ADDENDUM NO. 1
February 6th, 2025

PROJECT: TRI-TRY WSC
PUMP STATION IMPROVEMENTS

The following changes and/or additions shall be made to the Plans, Specifications, and Contract Documents for the above referenced project. Bidder shall acknowledge receipt of this Addendum by signing below and returning this Addendum with the Bid.

ASPERMONT, TEXAS
TRI-TRY WATER SYSTEM IMPROVEMENTS
PROPOSED SITE PLAN

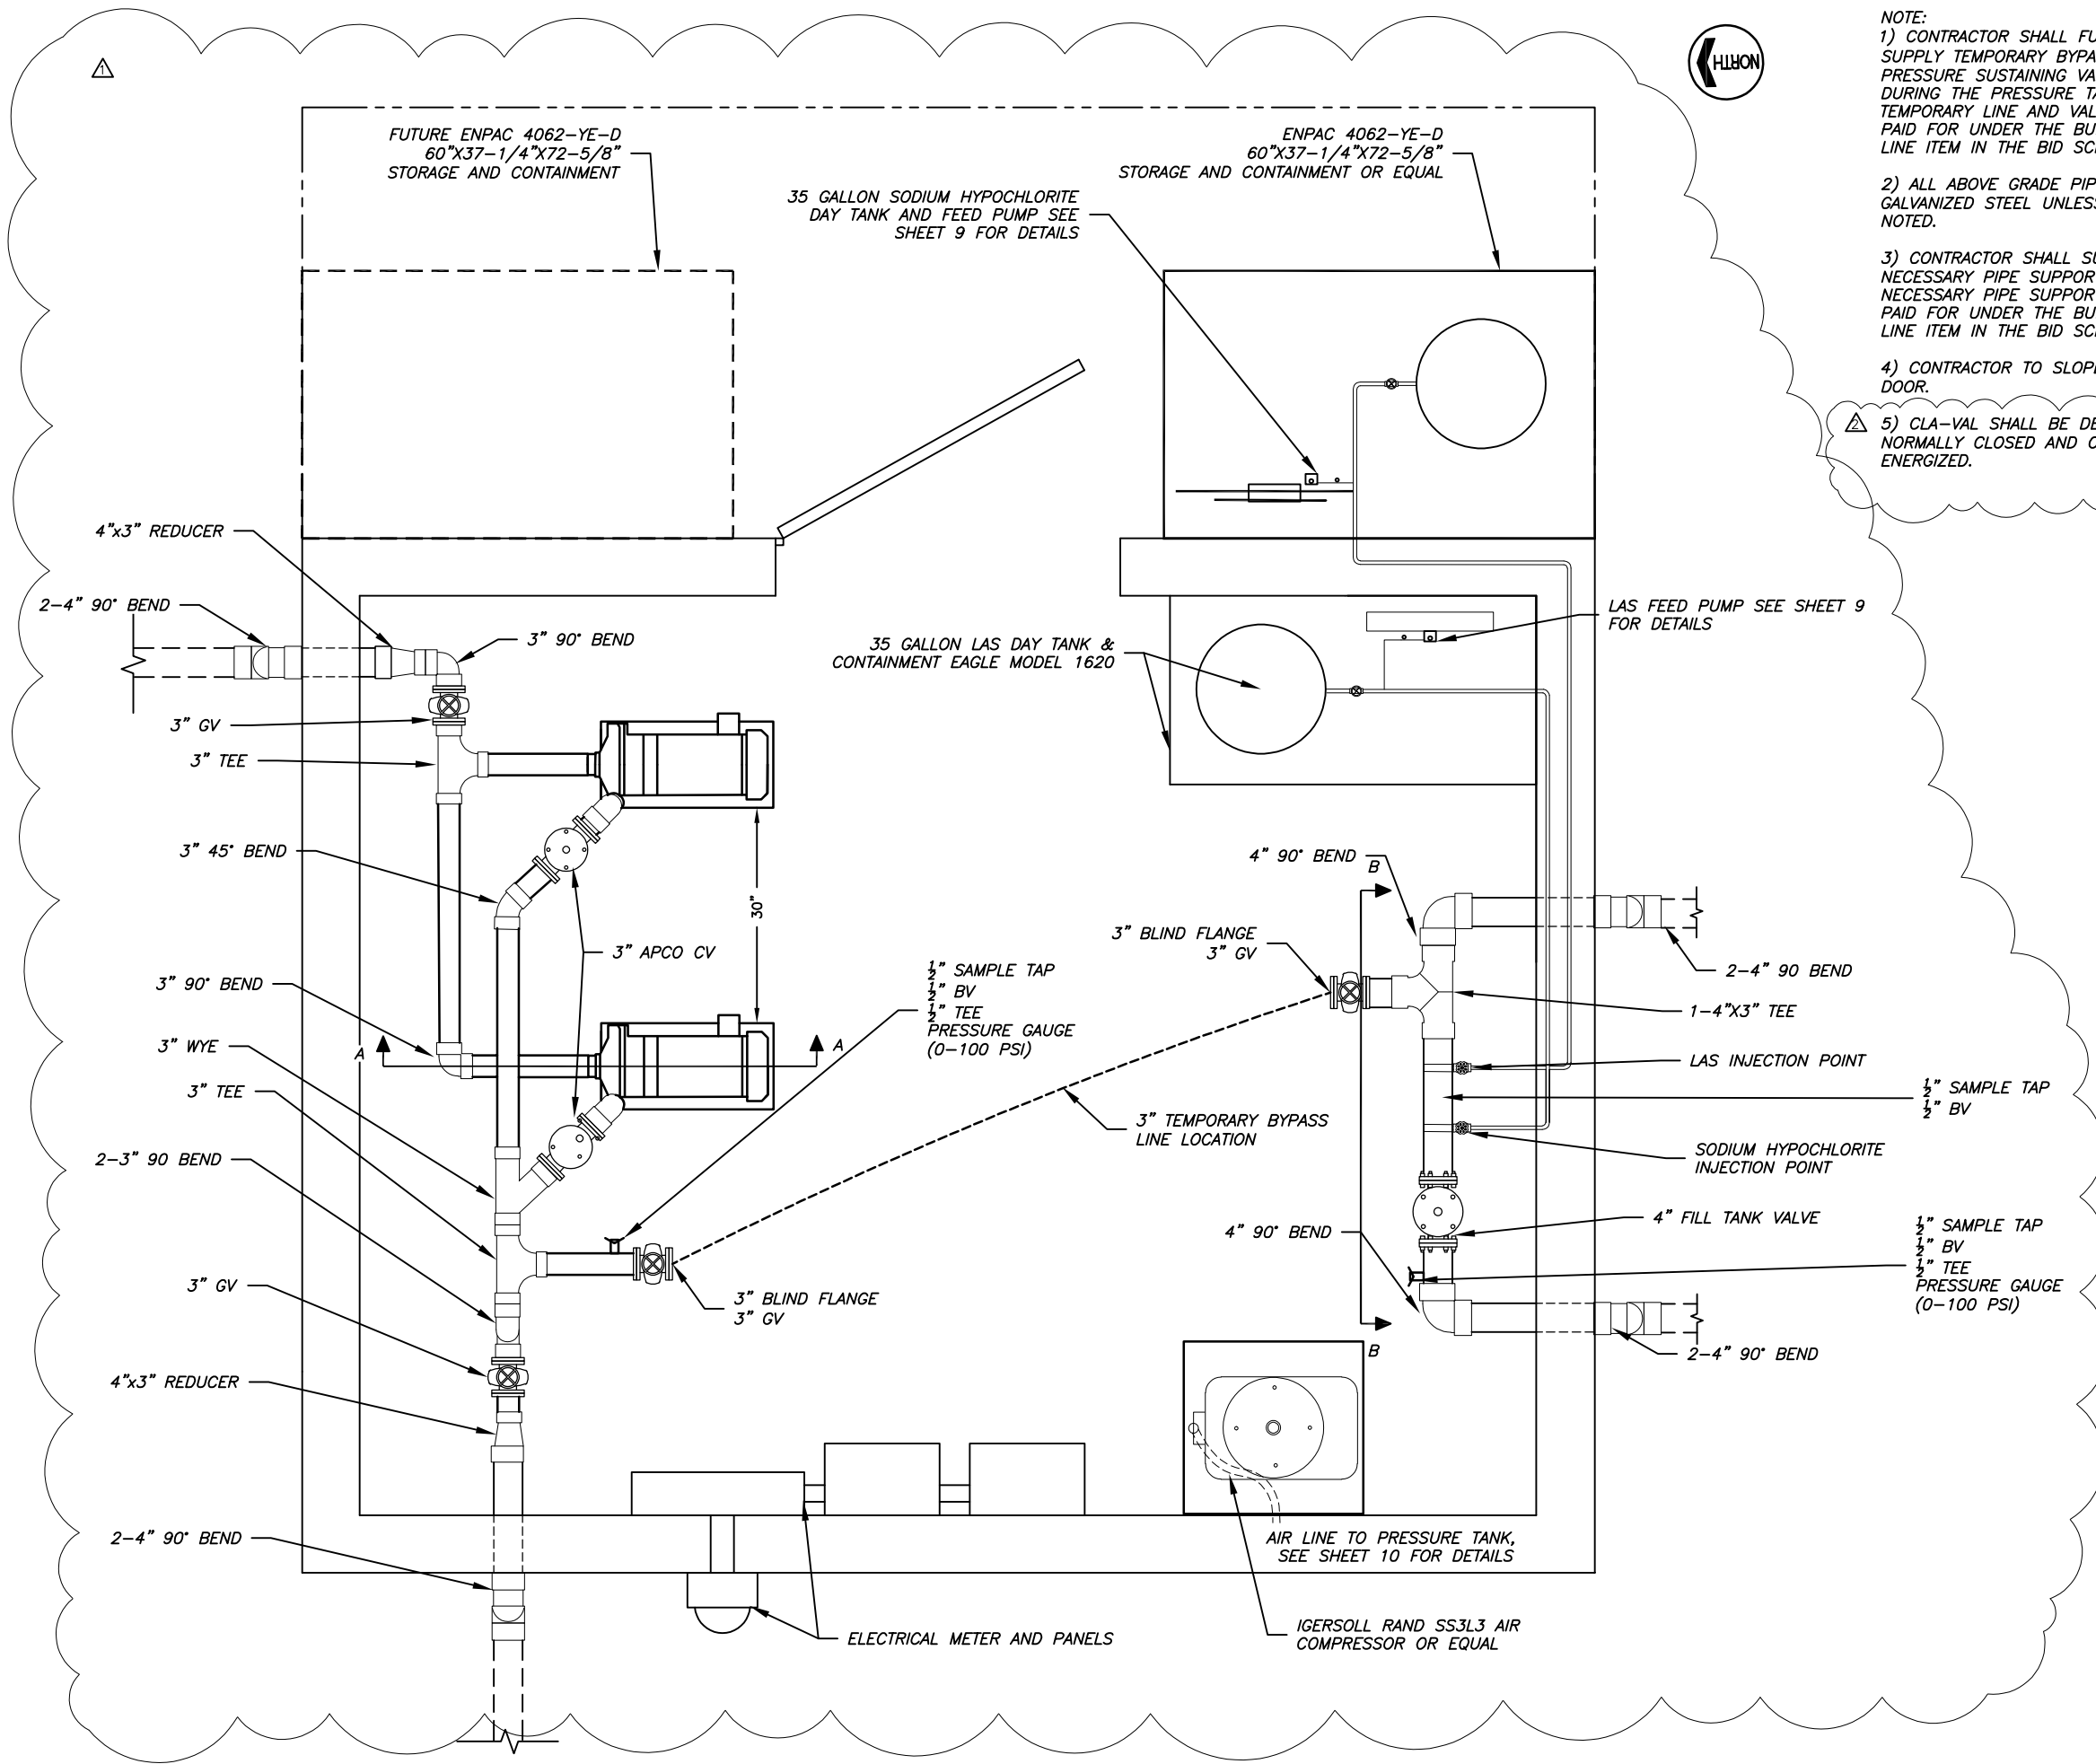
Sheet 5 – Proposed Site Plan – This sheet has been modified to modify the building orientation and provide updated details on the waterline connections.

ASPERMONT, TEXAS
TRI-TRY WATER SYSTEM IMPROVEMENTS
BUILDING LAYOUT

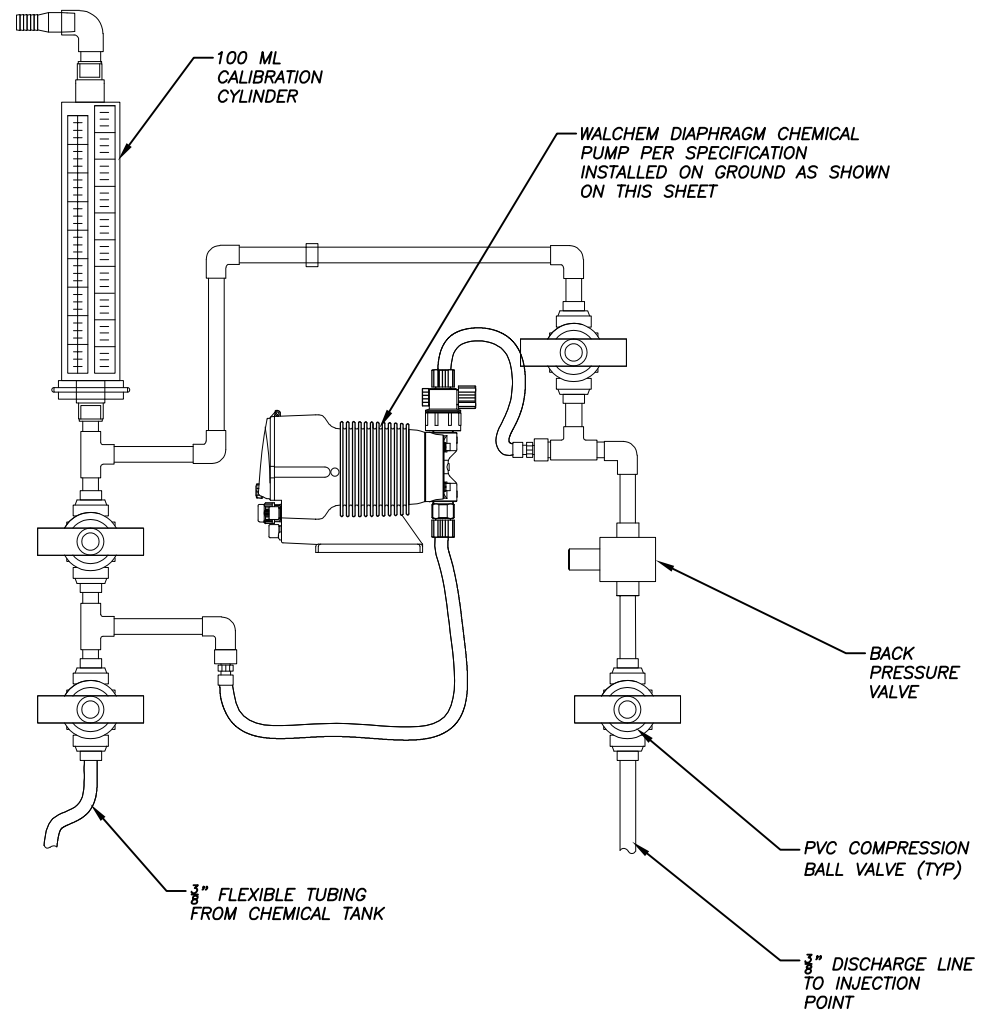
Sheet 6 – Building Layout – This sheet has been modified to update the building orientation and provide additional details on the tank fill valve.

△ 5) CLA-VAL SHALL BE DESIGNED TO BE NORMALLY CLOSED AND OPEN WHEN ENERGIZED.

ASPERMONT, TEXAS
 TRI-TRY WATER SYSTEM IMPROVEMENTS
 PIPING AND PUMPING SECTIONS

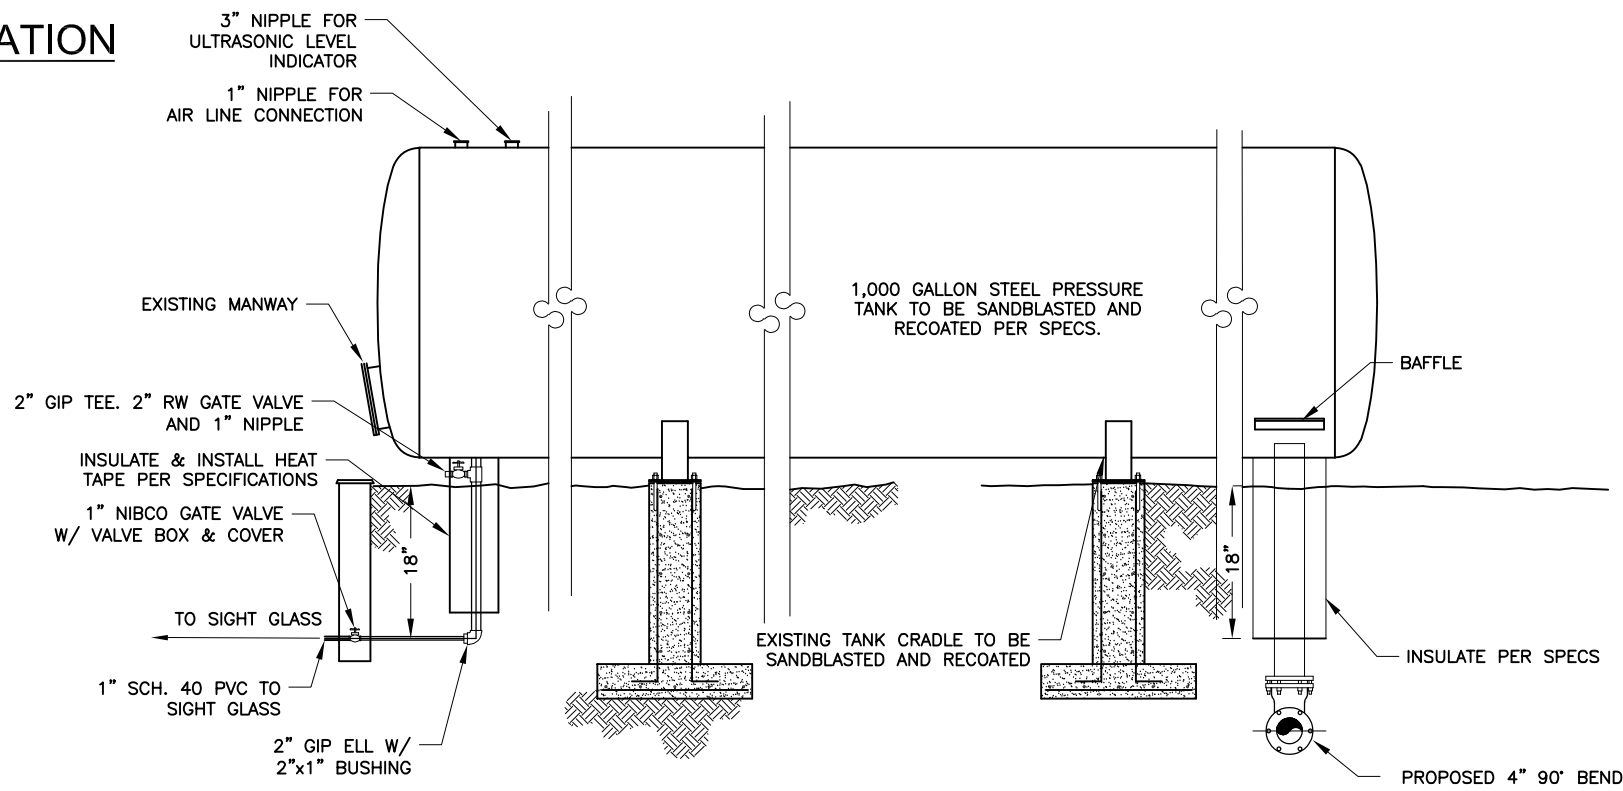
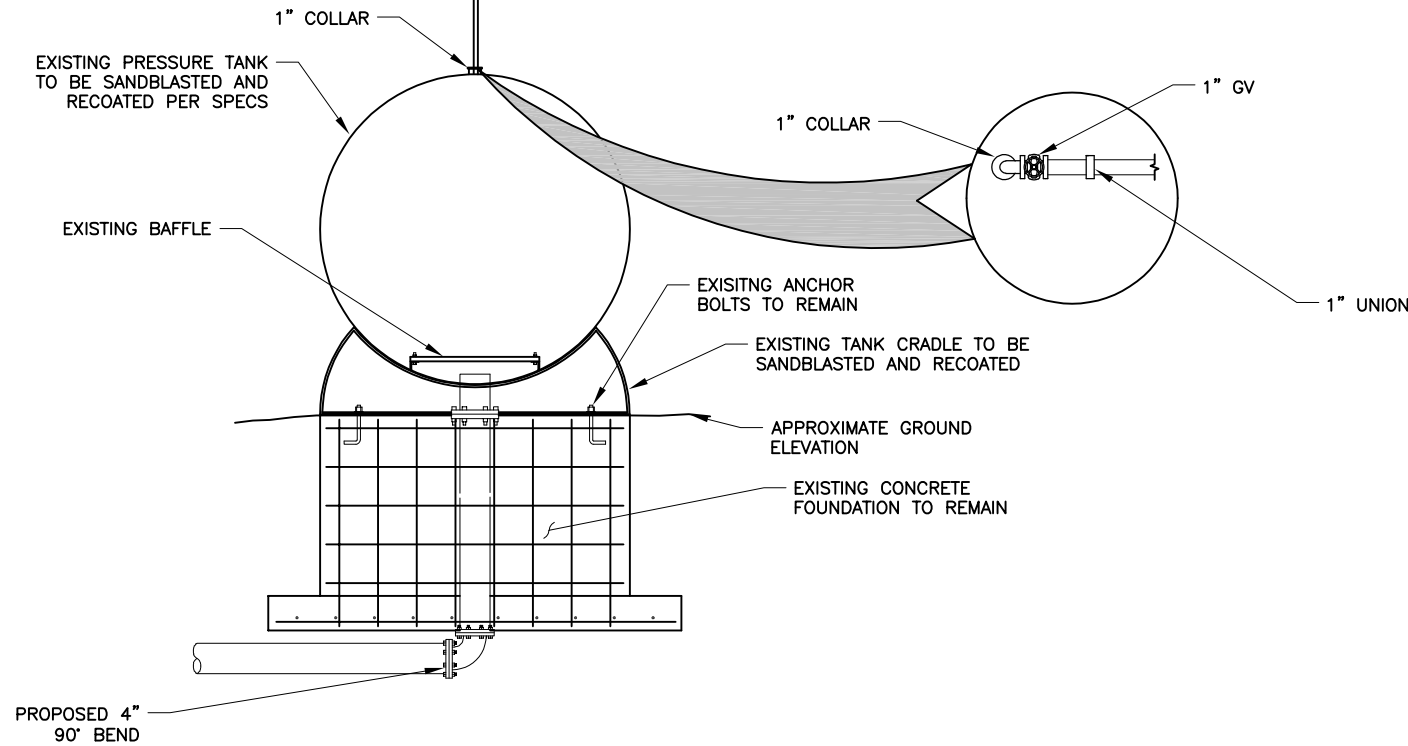
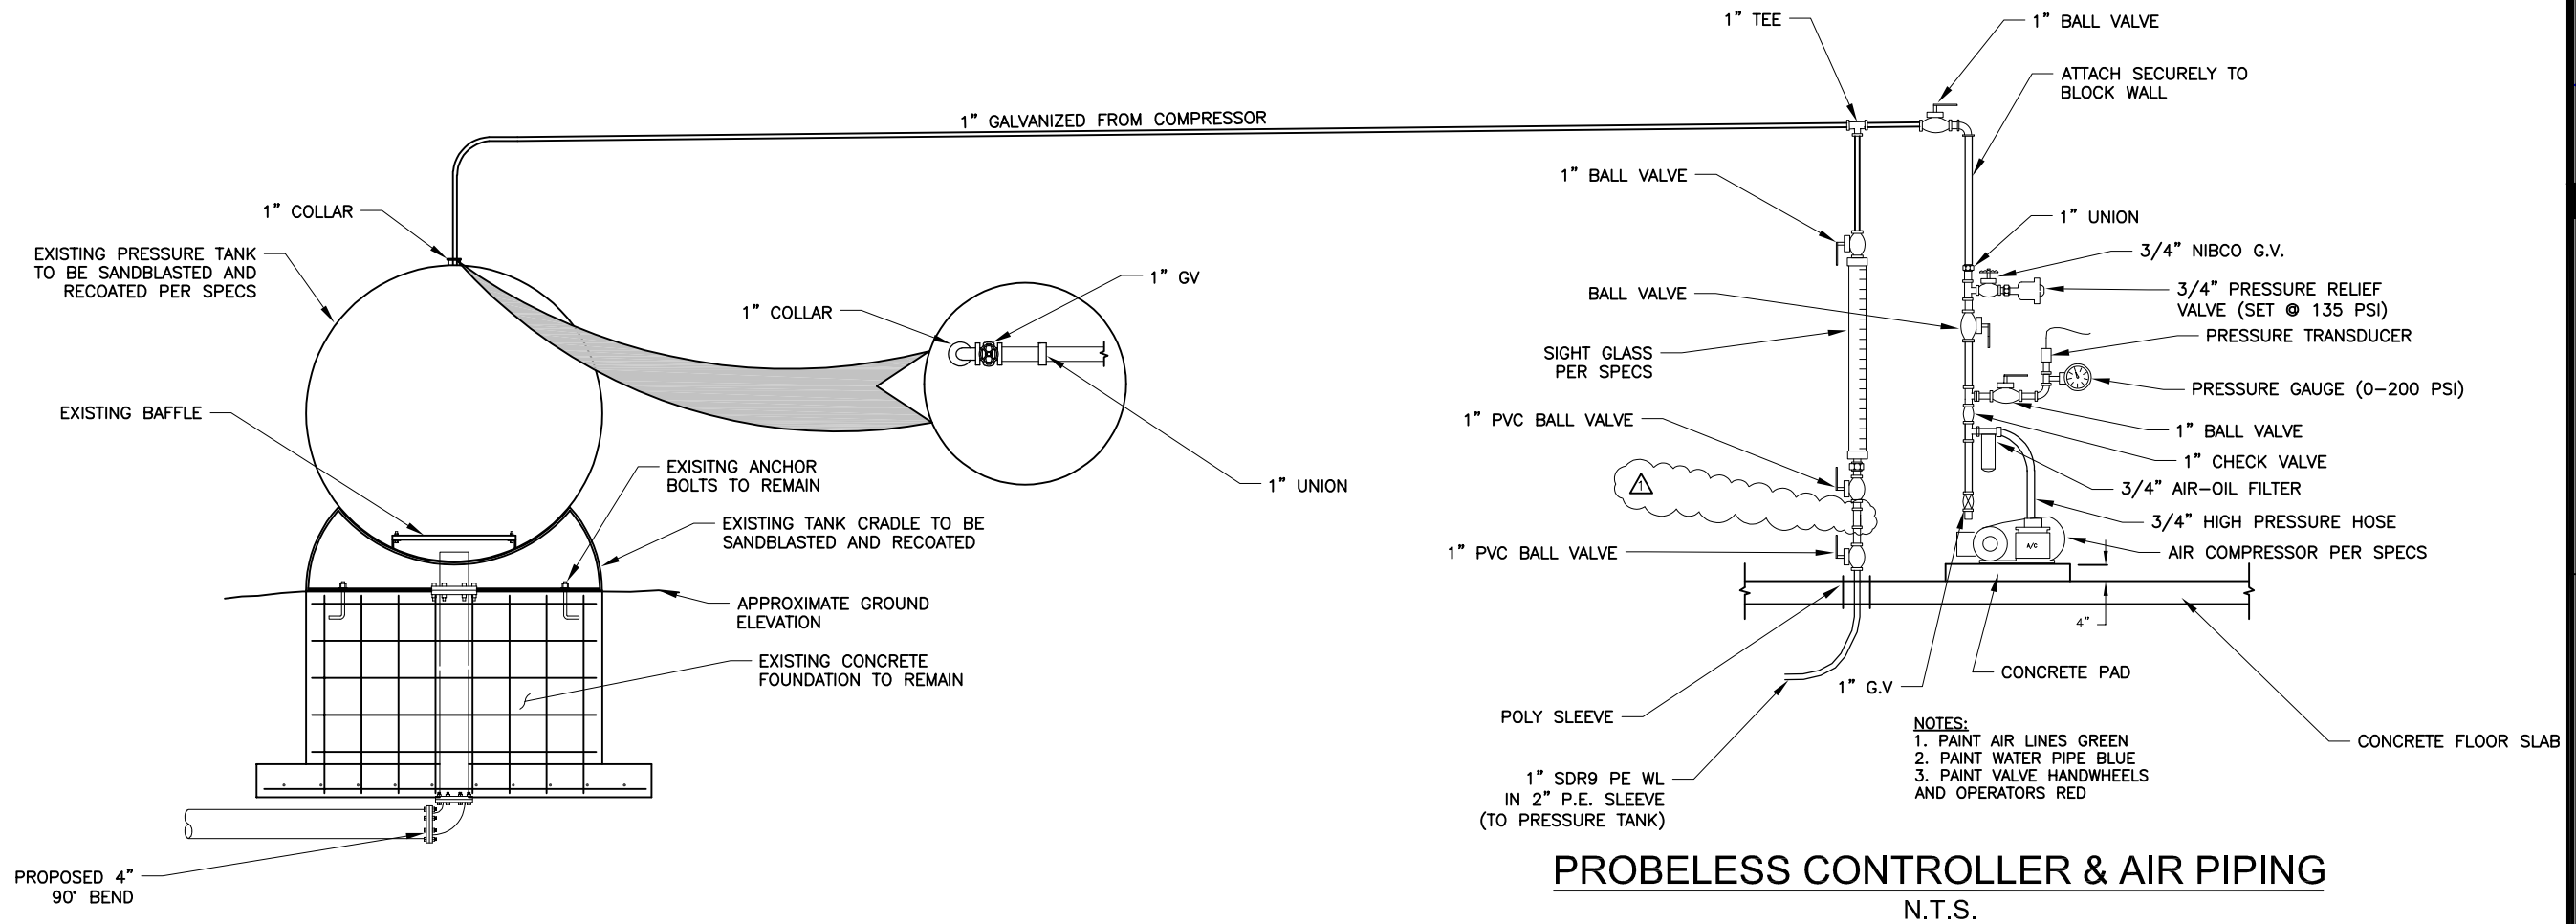
Sheet 9 – Piping and Pump Sections – This sheet has been modified to provide additional details on the tank fill valve model and materials.
